45 The Vineyard Planning Changes

Date: August 2024
Doc No. 5008

Revision G

Since activating the planning permission (ref 19/0954/VRC) the scheme has undergone both a stage 3 design review and stage 4 design development. This document seeks to present the design updates with a view to substituting the existing planning drawings with an updated set to maintain the completeness of the consent, for the avoidance of doubt and in the interests of proper planning. The design updates have been made for the following reasons:

Drawing Title:
SECTION AA - Unit 45b
PROPOSED

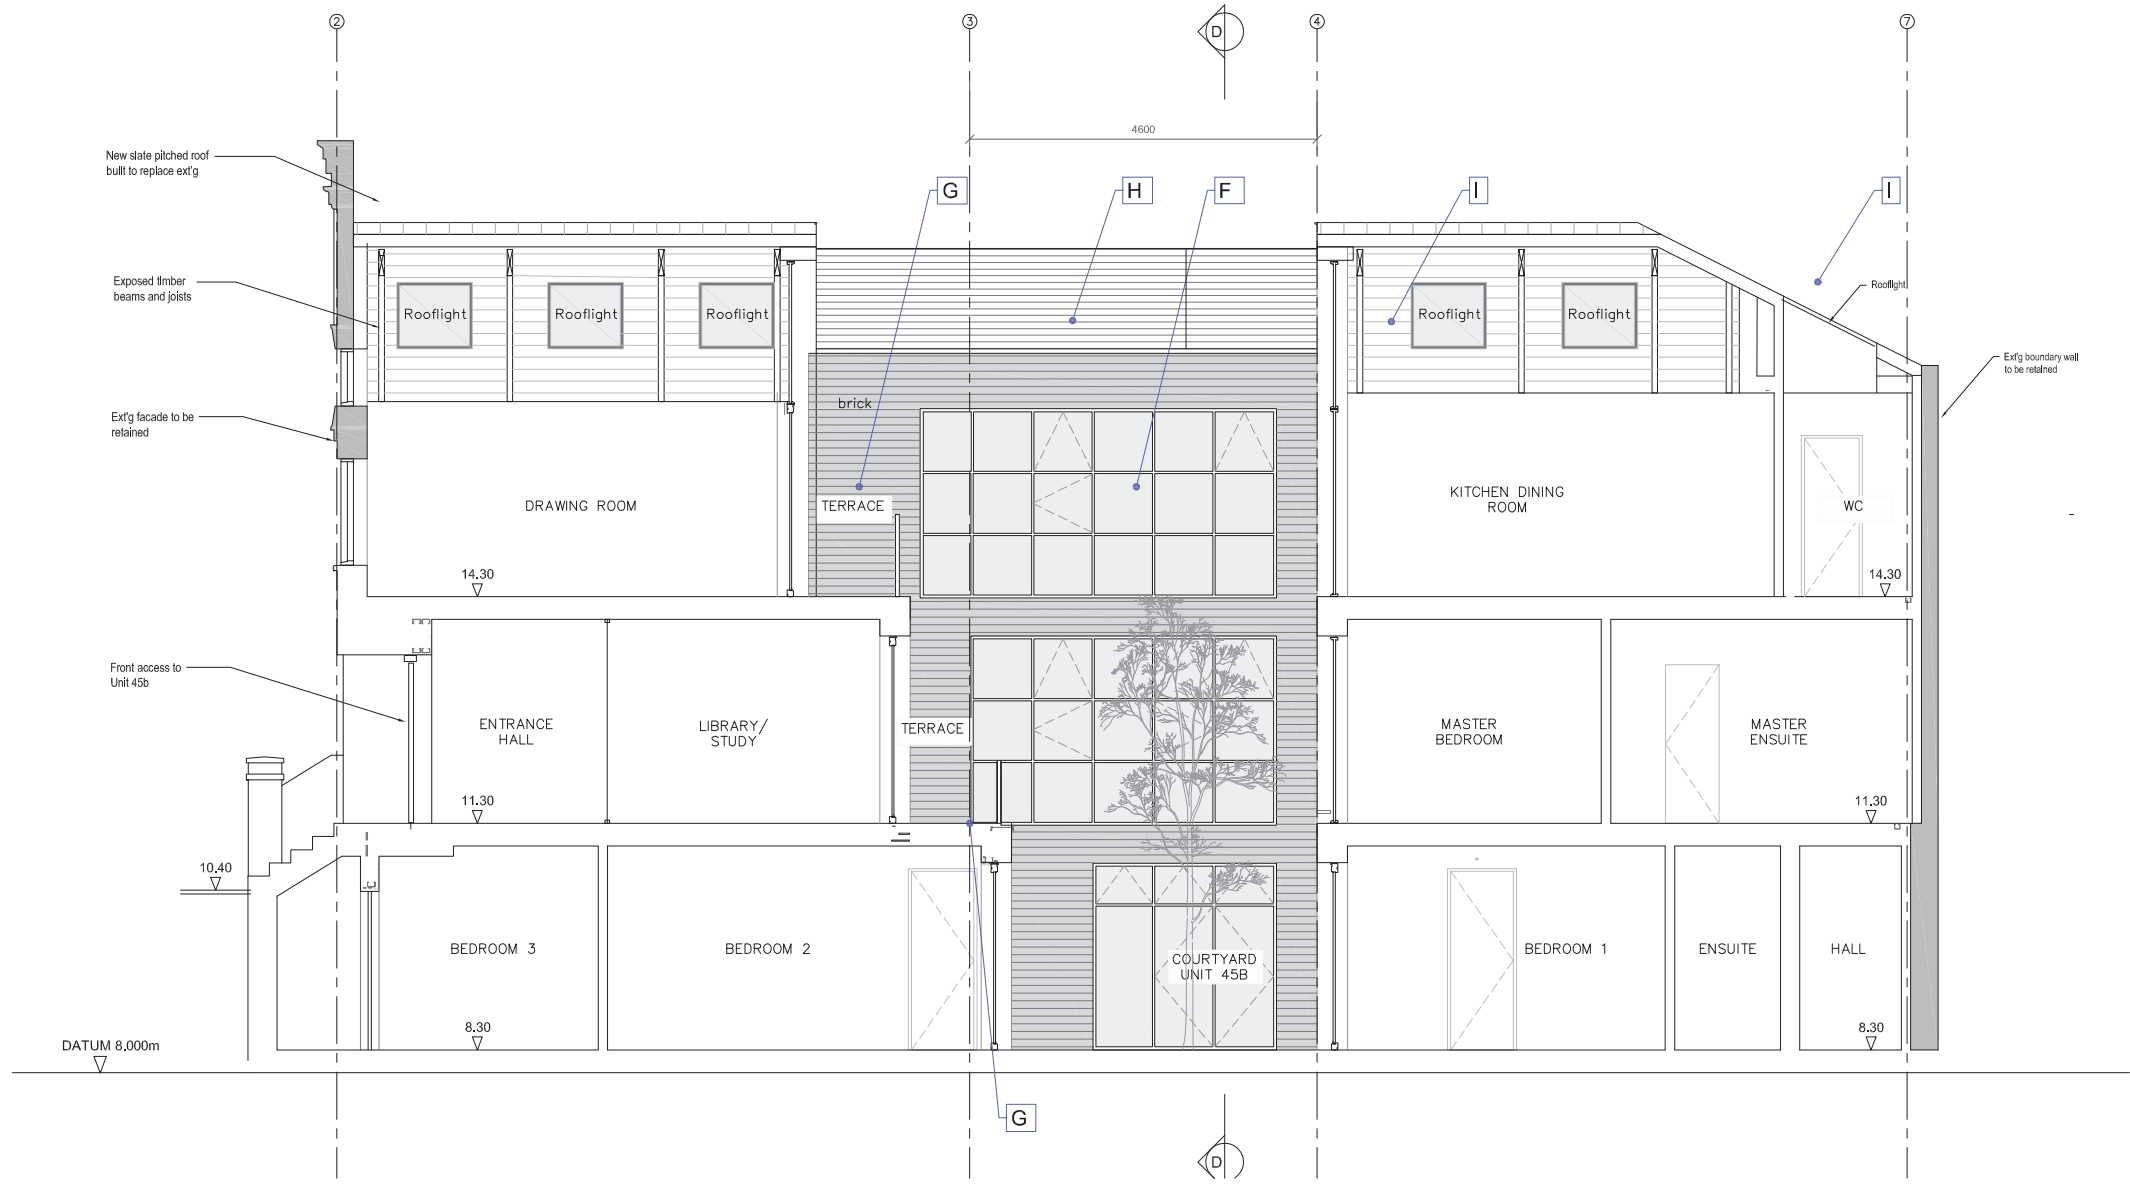
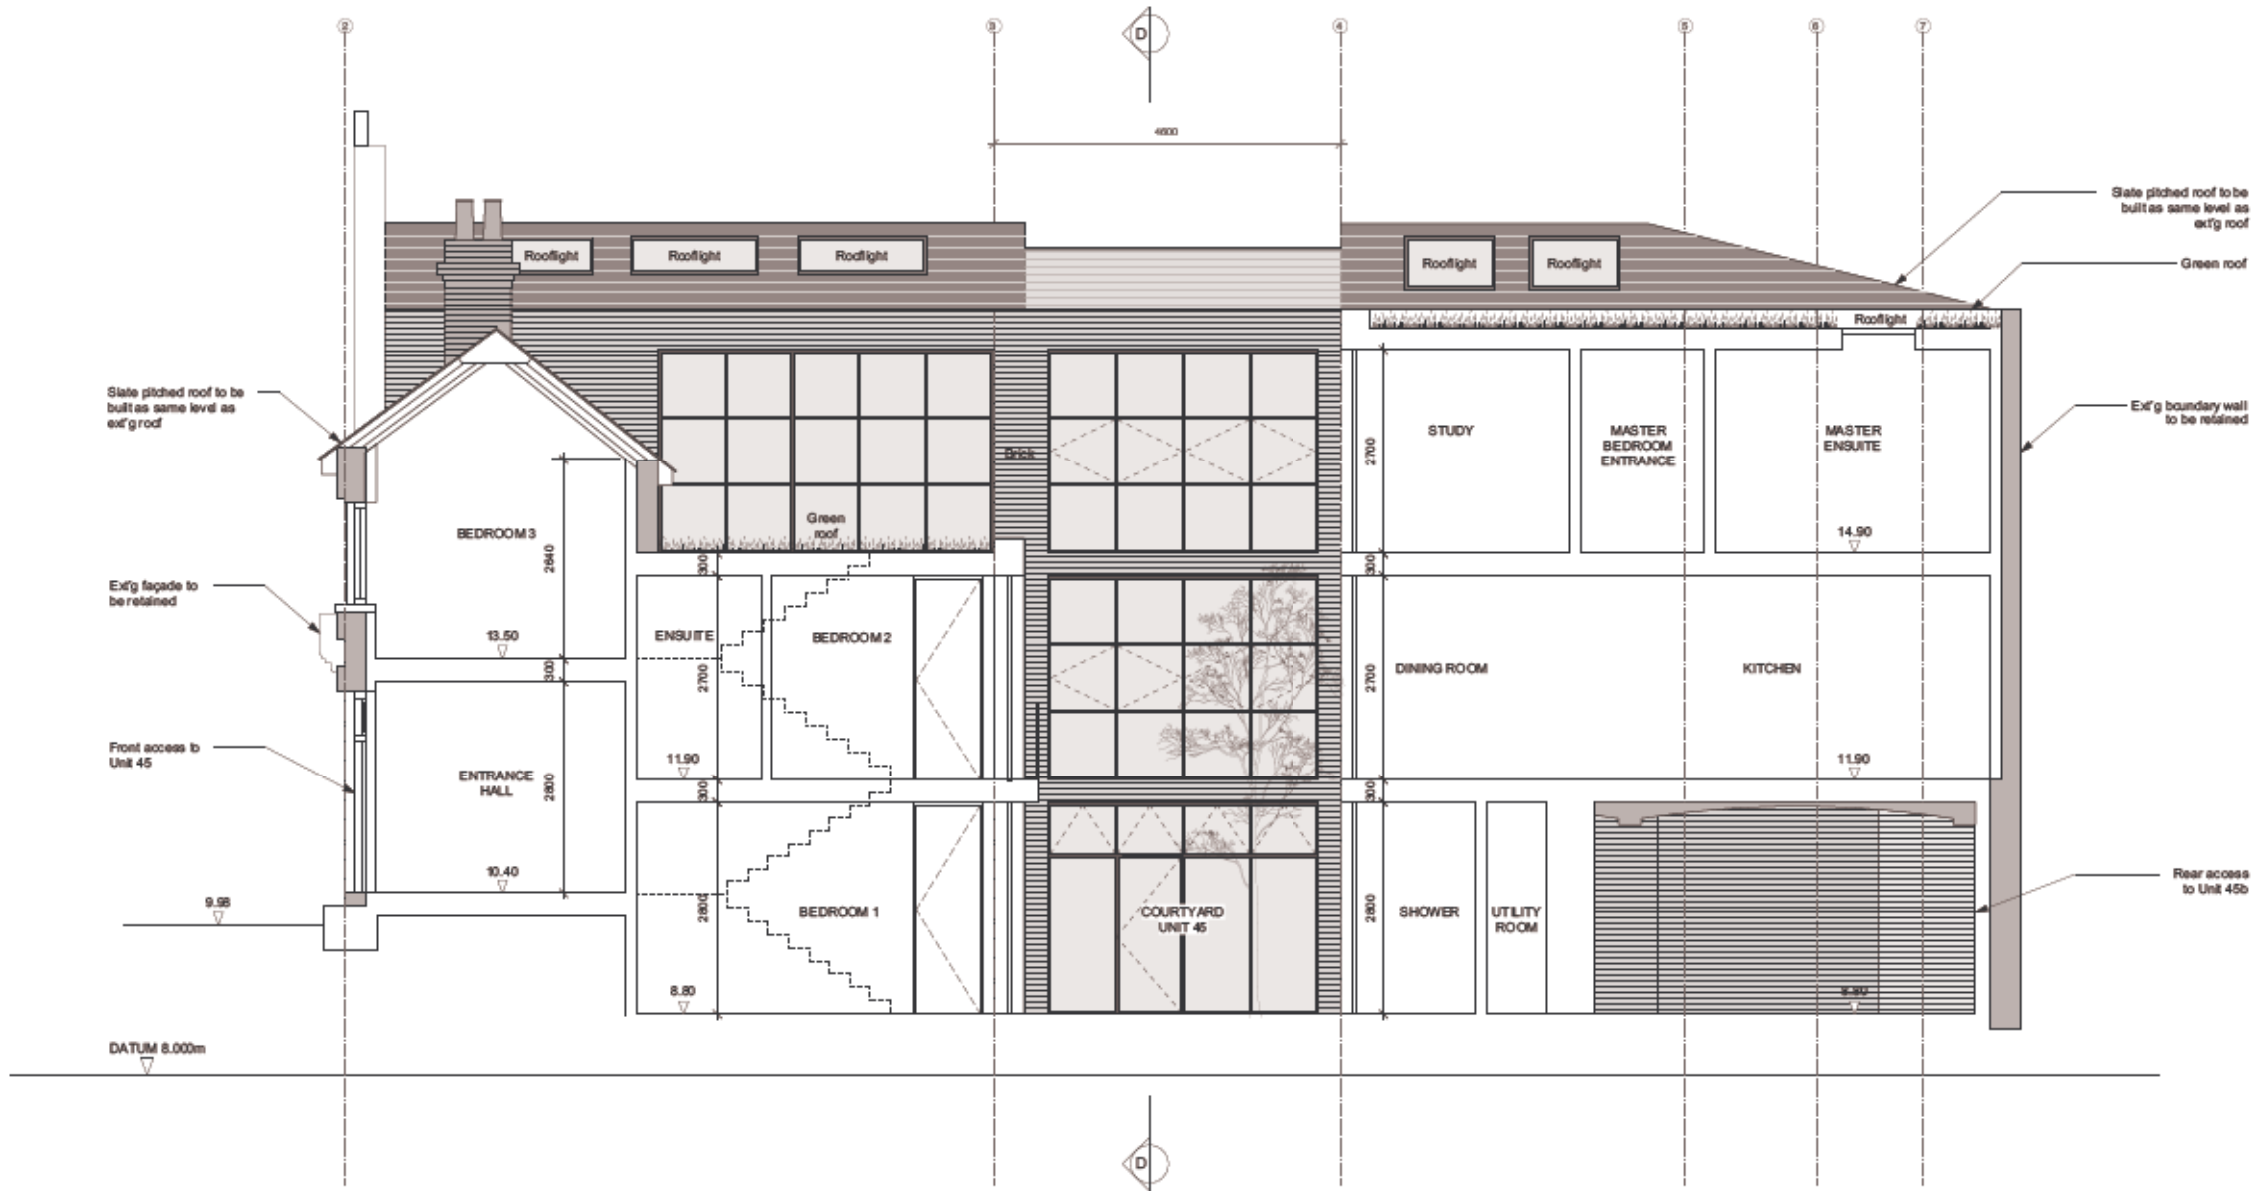
- A INTERNAL ARRANGEMENT AMENDED (SEE SUMMARY OF INTERNAL CHANGES IN SEPARATE DOC)
- B BICYCLE STORAGE ARRANGED AROUND COURTYARD (CLOSER TO UNIT ENTRANCES)
- C LEVEL ENTRANCE TO 45A
- D ENTRANCE LEVEL SHOWN HERE (BEDROOM SHOWN ON LEVEL 02) - NOTE: ACTUAL LEVEL TO THESE ROOMS REMAINS THE SAME
- E TERRACE DIVIDED BETWEEN UNITS WITH GREEN WALL
- F COURTYARD FLANK WALL LOWERED IN HEIGHT (SEE ELEVATION)
- G TERRACE ADDED
- H WINDOW AMENDED (POSITION OR SIZE)
- I ROOFLIGHT OMITTED
- J GREEN ROOF OMITTED
- K -
- L SOFFIT PROFILE CHANGED
- M BRICK SOLDIER COURSE OMITTED
- N SERVICE ENCLOSURES CHANGED
- O PRIVACY SCREEN ADDED
- P CAR PARK GATE AMENDED
- Q PLANT ROOM DOOR ADDED
- R WINDOW POSITION AMENDED
- S -
- T PV PANEL ADDED
- U WINDOW OMITTED

Drawing Title:
SECTION BB - Unit 45
PROPOSED

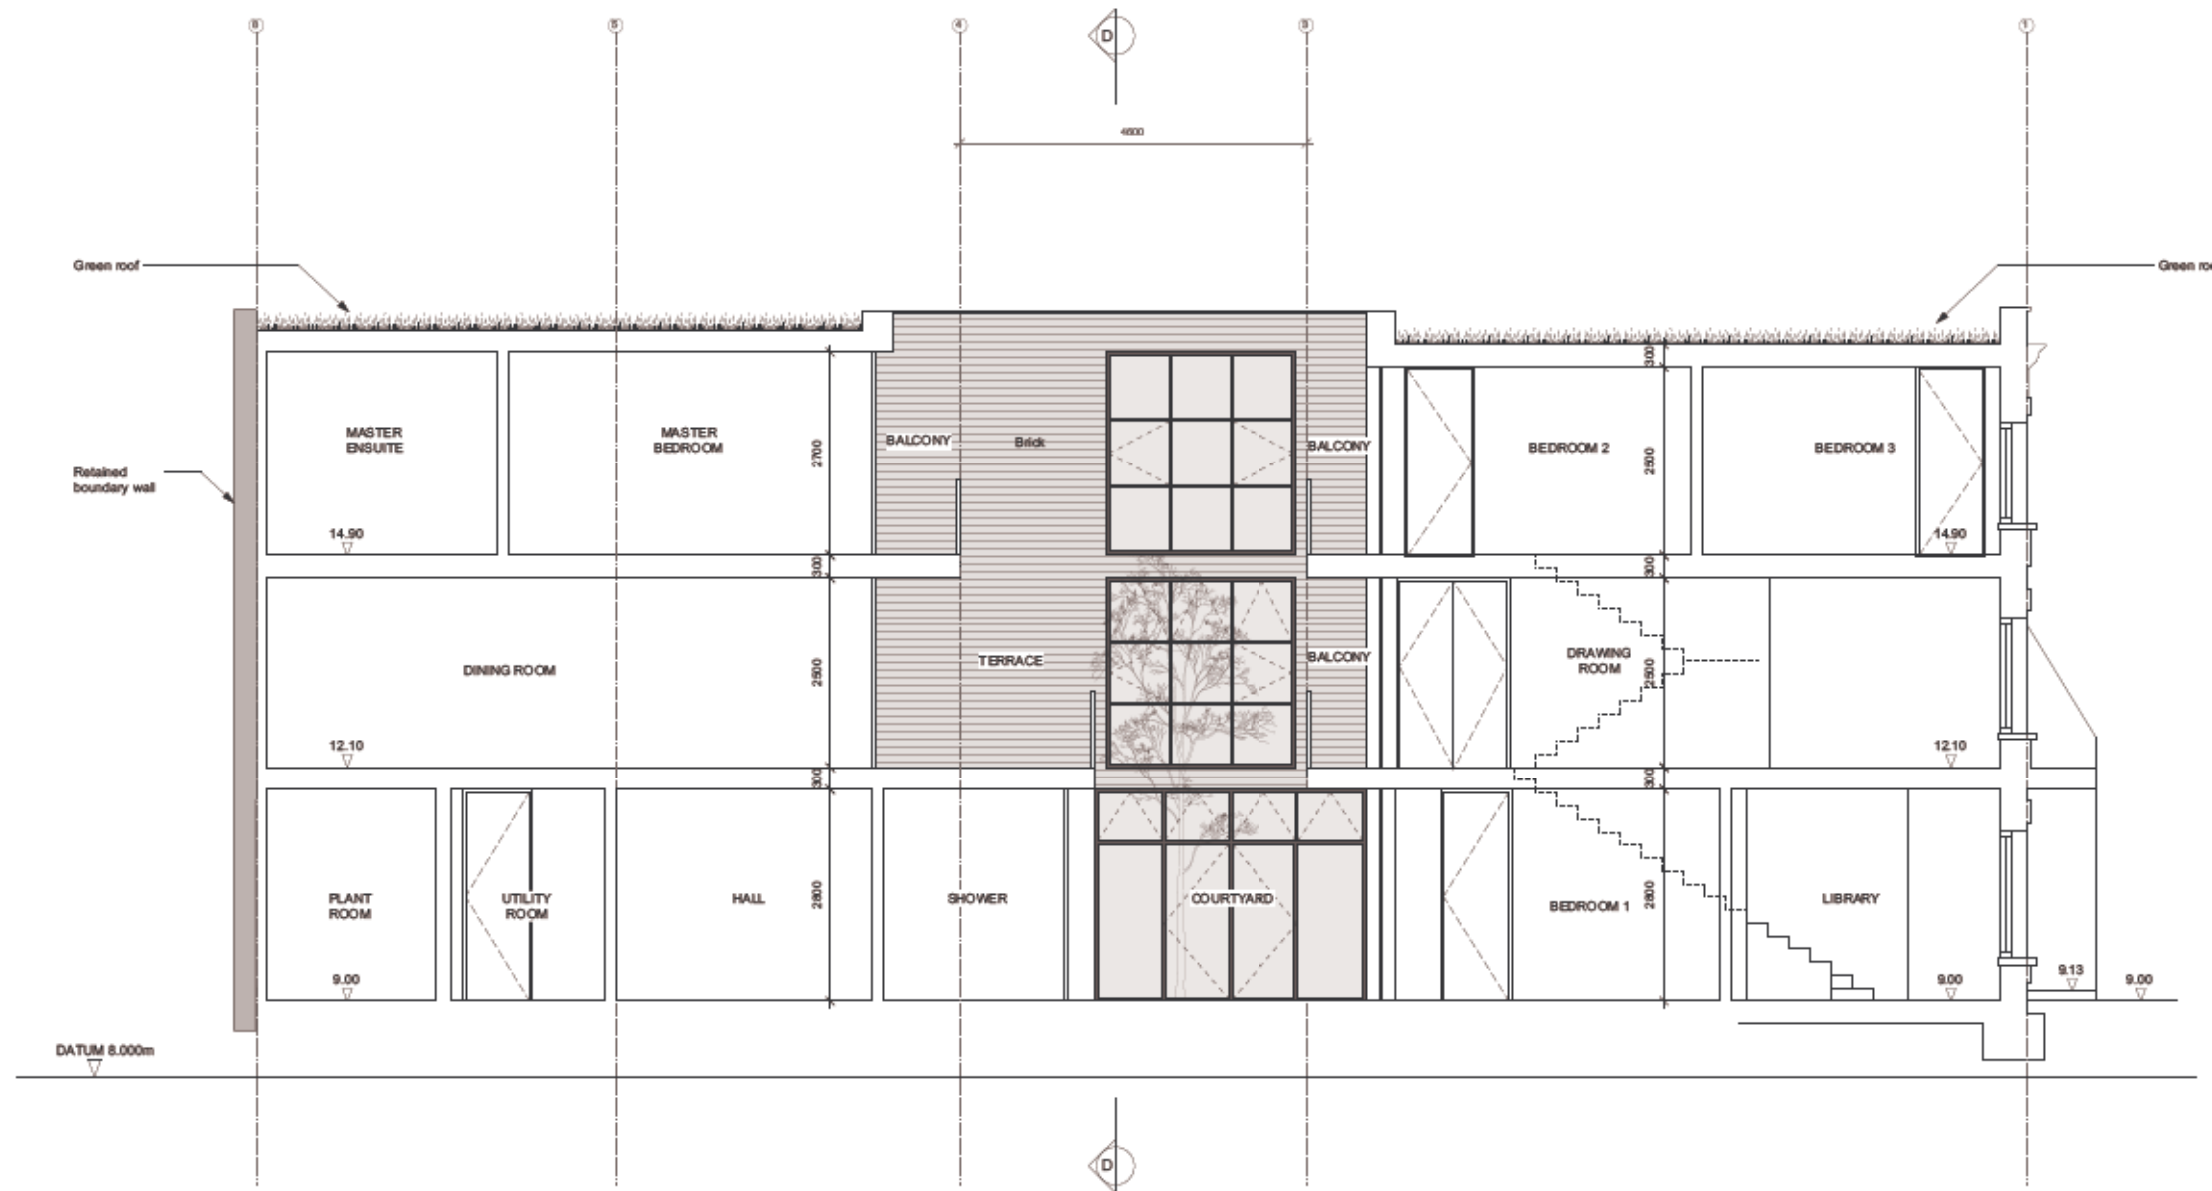
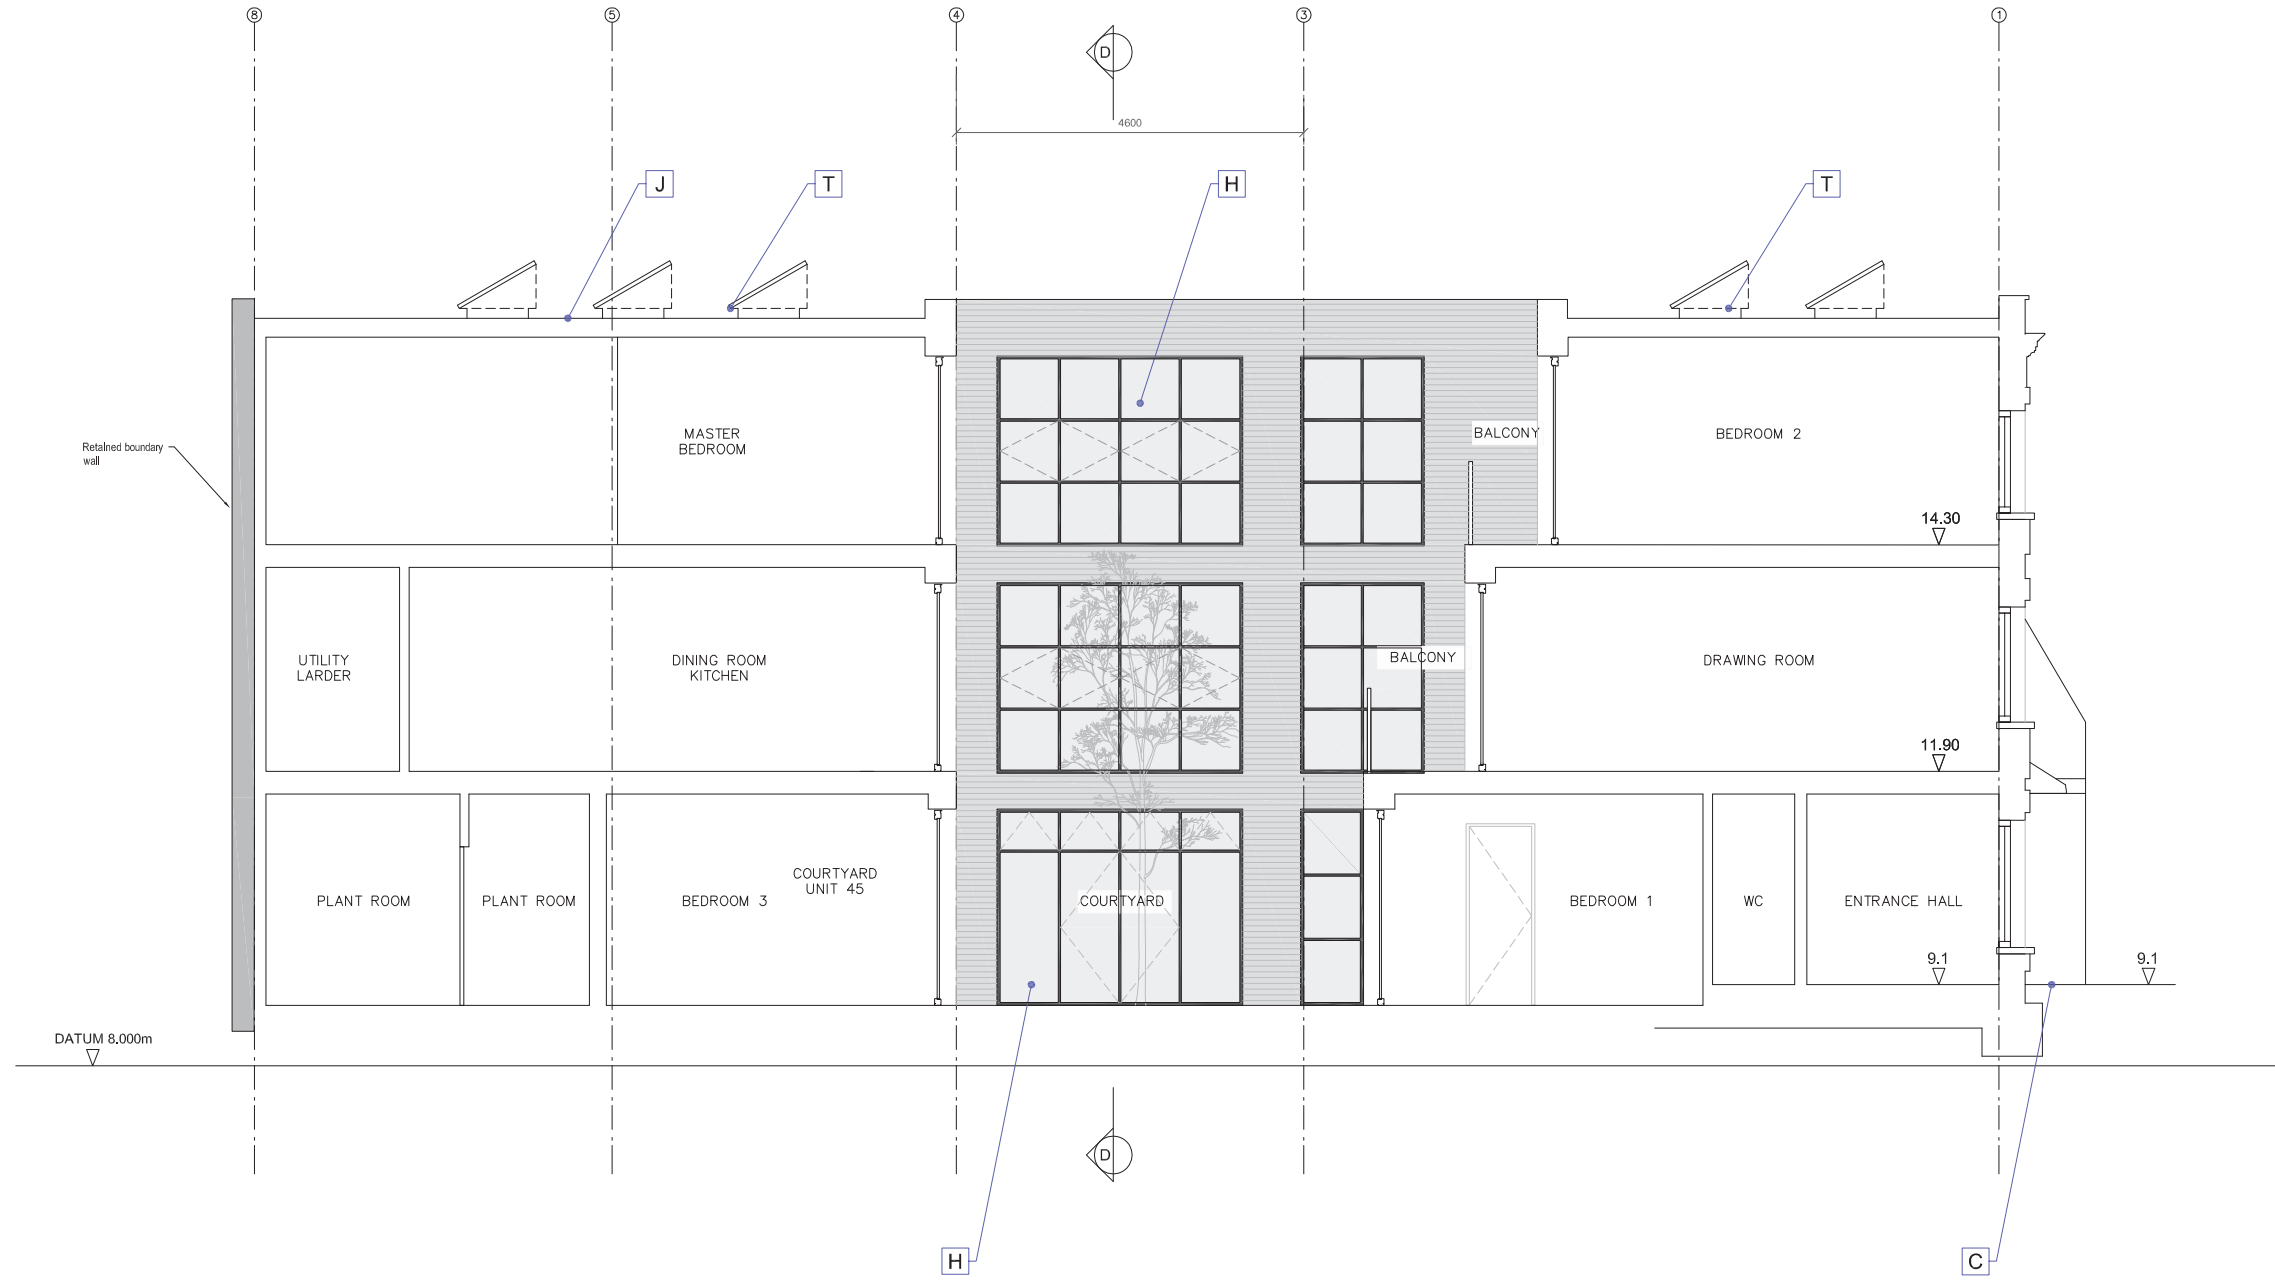
- A INTERNAL ARRANGEMENT AMENDED (SEE SUMMARY OF INTERNAL CHANGES IN SEPARATE DOC)
- B BICYCLE STORAGE ARRANGED AROUND COURTYARD (CLOSER TO UNIT ENTRANCES)
- C LEVEL ENTRANCE TO 45A
- D ENTRANCE LEVEL SHOWN HERE (BEDROOM SHOWN ON LEVEL 02) - NOTE: ACTUAL LEVEL TO THESE ROOMS REMAINS THE SAME
- E TERRACE DIVIDED BETWEEN UNITS WITH GREEN WALL
- F COURTYARD FLANK WALL LOWERED IN HEIGHT (SEE ELEVATION)
- G TERRACE ADDED
- H WINDOW AMENDED (POSITION OR SIZE)
- I ROOFLIGHT OMITTED
- J GREEN ROOF OMITTED
- K -
- L SOFFIT PROFILE CHANGED
- M BRICK SOLDIER COURSE OMITTED
- N SERVICE ENCLOSURES CHANGED
- O PRIVACY SCREEN ADDED
- P CAR PARK GATE AMENDED
- Q PLANT ROOM DOOR ADDED
- R WINDOW POSITION AMENDED
- S -
- T PV PANEL ADDED
- U WINDOW OMITTED
